# KENWOOD

ASB-1032

## Service Bulletin

**Subject:** TS-450/690S Low Mic Gain w/DSP-100

IF Unit (X48-3090-XX)  
Foil Side View

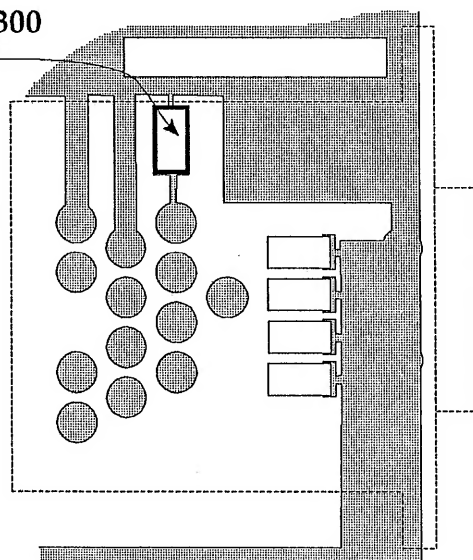
Proper microphone gain/ALC readings cannot be obtained unless the user adjusts the TX GAIN potentiometer on the rear of the DSP-100. This irregularity is caused by an instability of the DSP-100 MIC amplifier (IC-5).

Replace with R300  
(R92-0670-05)

Remove capacitor C200 from the IF unit on the transceiver, and replace it with R300, a chip jumper wire.

Qty	Description	Kenwood Part No.	Circuit Description
1	Chip Jumper	R92-0670-05	R300
